REMARKS

Prior to examination on the merits on this divisional application, Applicants respectfully request entry and consideration of this Preliminary Amendment.

FIG. 4

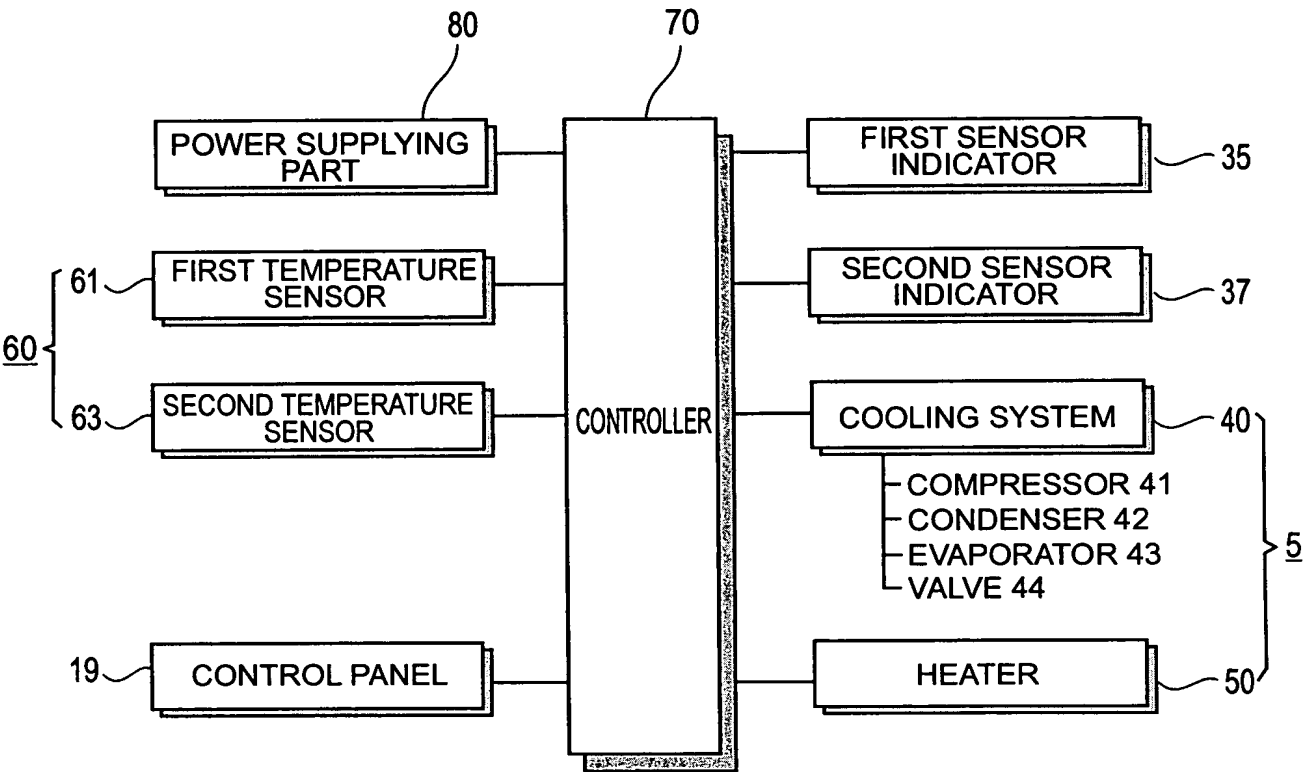
Figure 4 has been amended to show the compressor, the condenser, the evaporator, and the valve.

The specification is modified to identify the application as a divisional application. The specification has been amended to add the reference numerals for the condenser and the valve in

Figure 4.

FIG. 5a

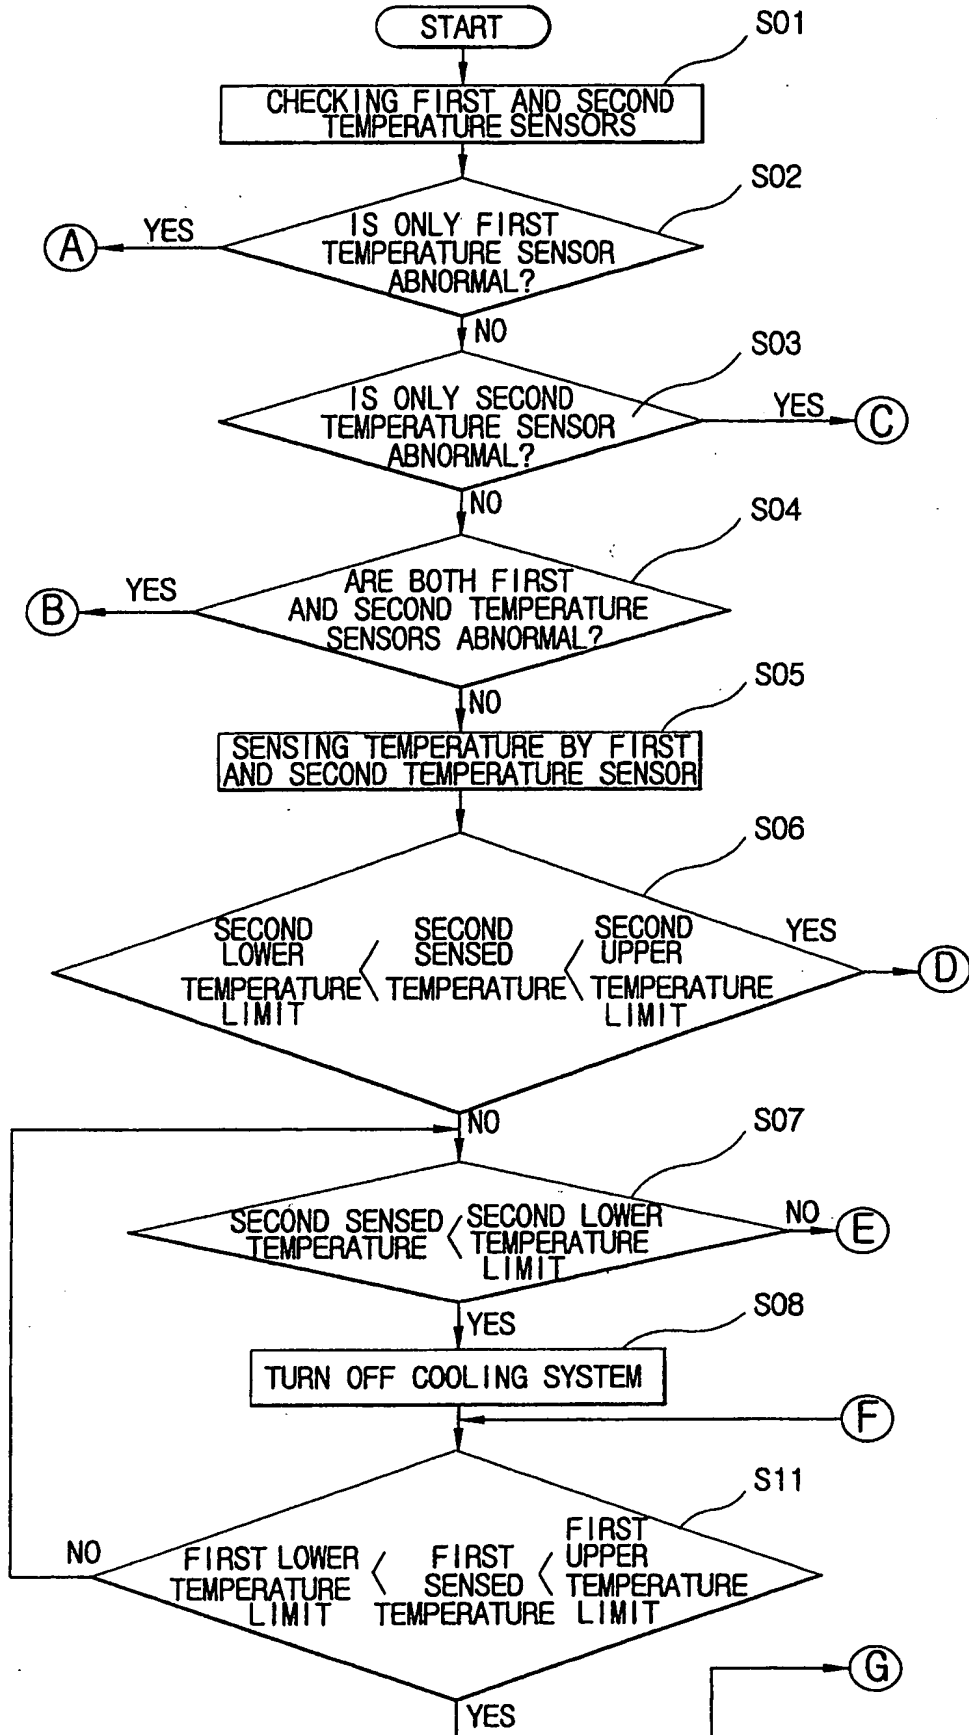
“SENSOR” in step S01 in Figure 5a has been replaced with “SENSORS.”

FIG. 5b

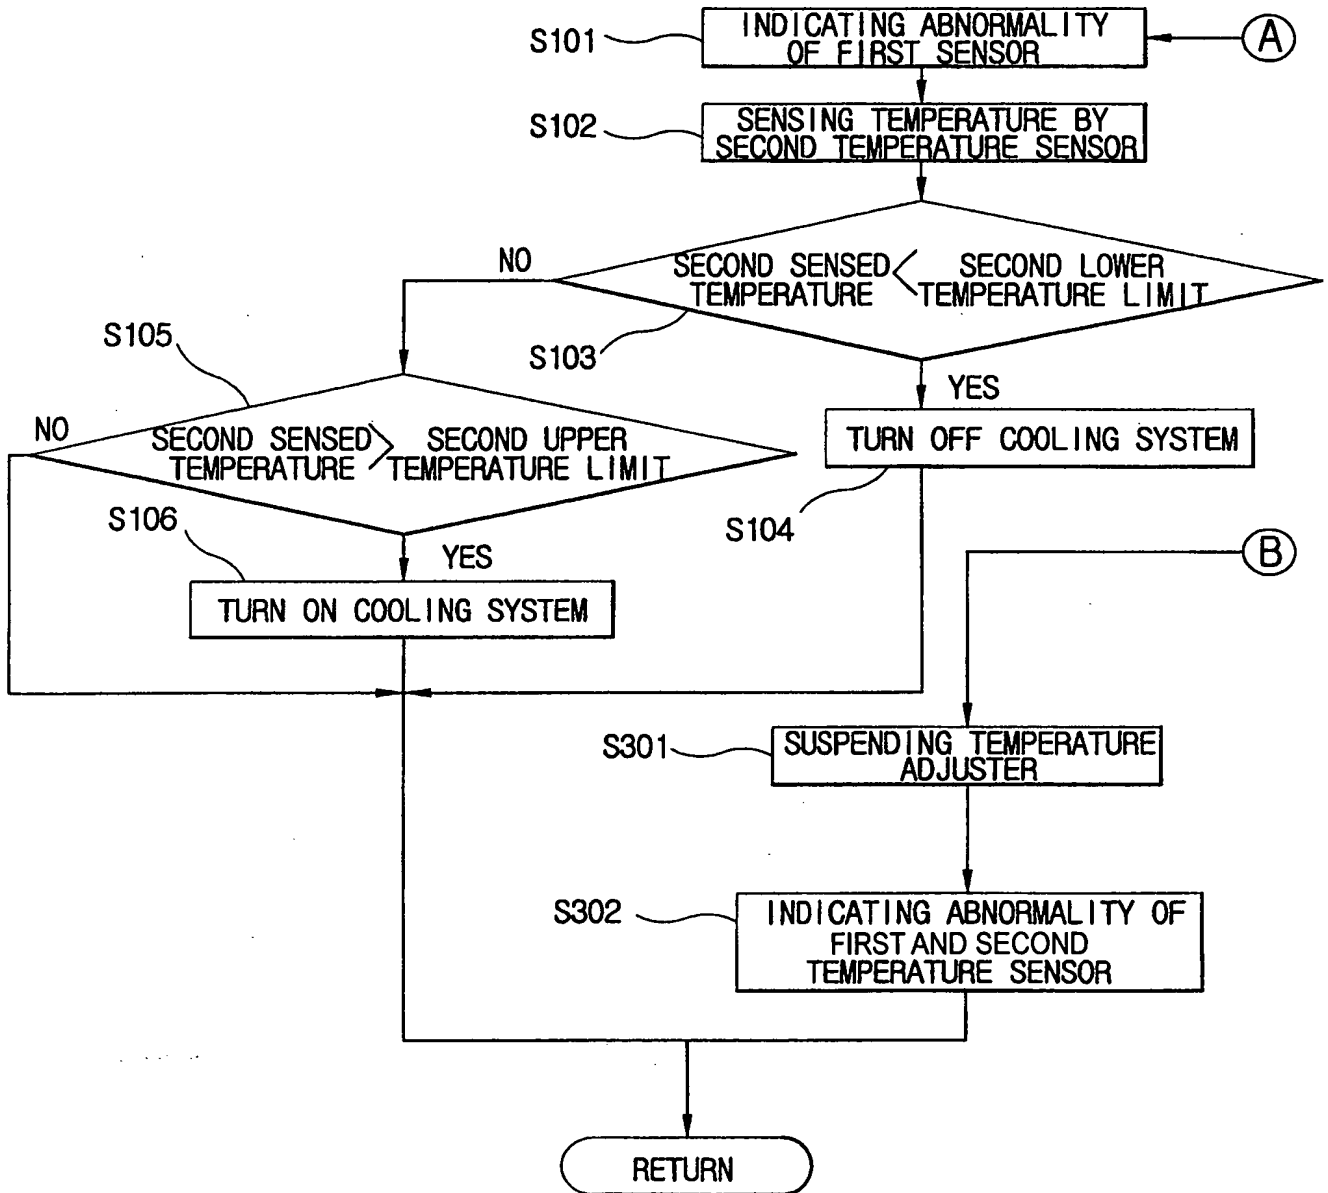
“FIEST” in step S302 in Figure 5b has been replaced with “FIRST.”

FIG. 6a

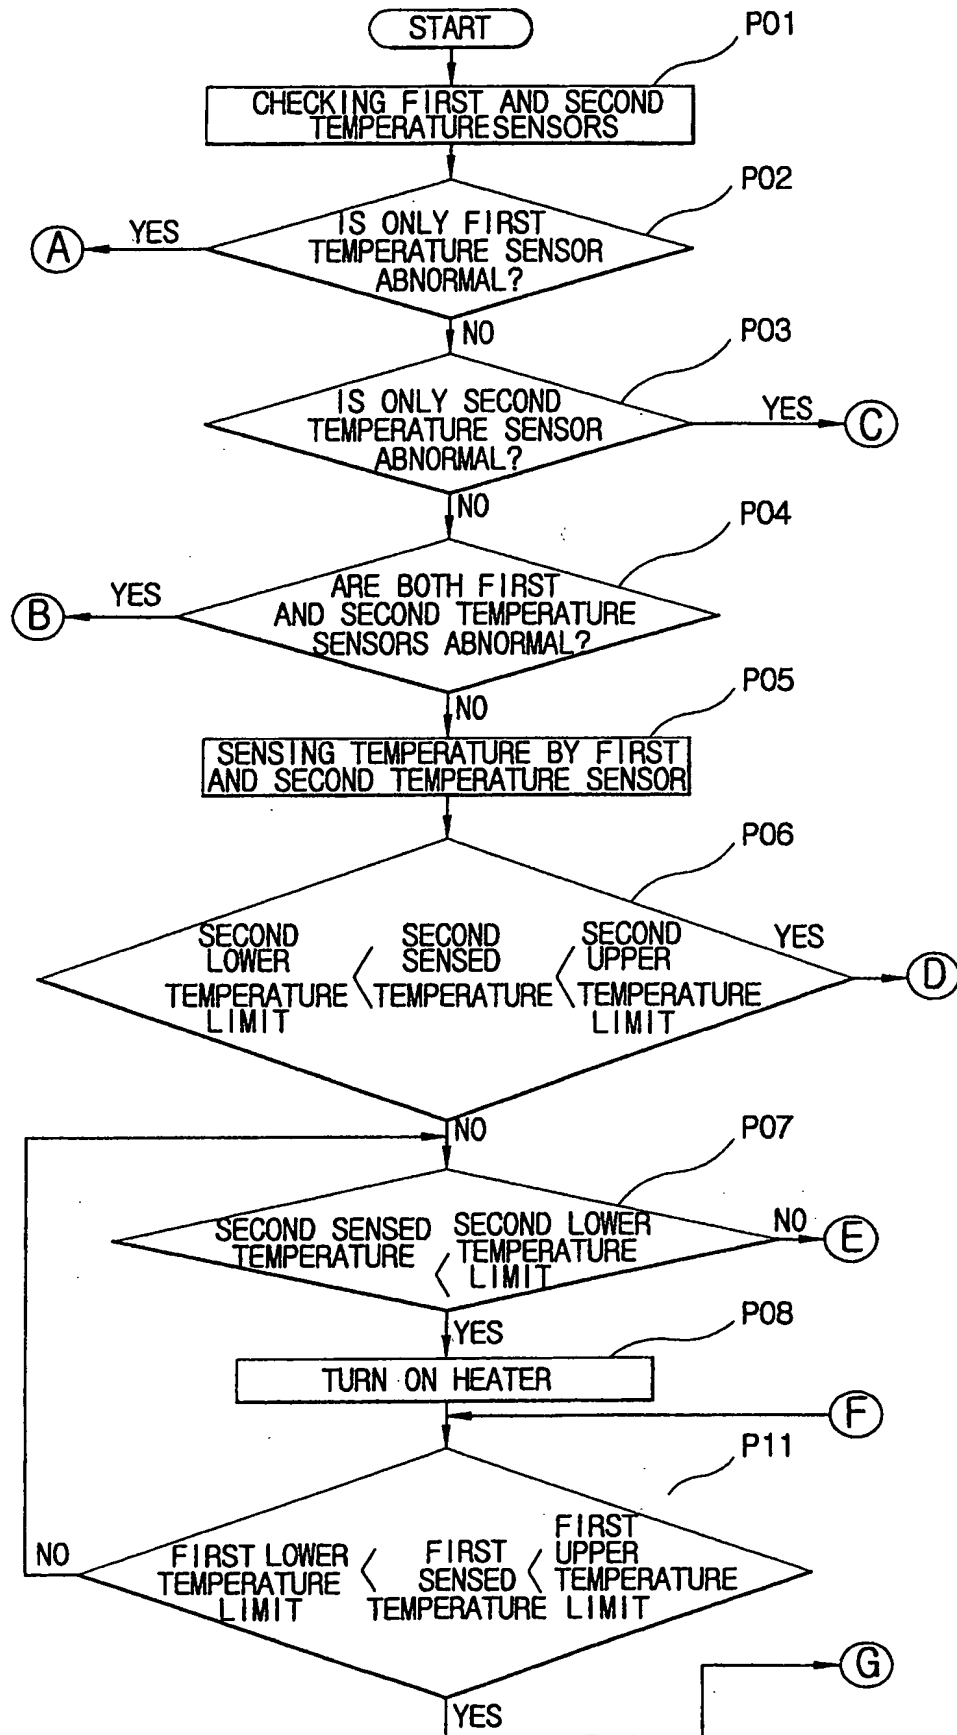
“SENSOR” in step P01 in Figure 6a has been replaced with “SENSORS.”
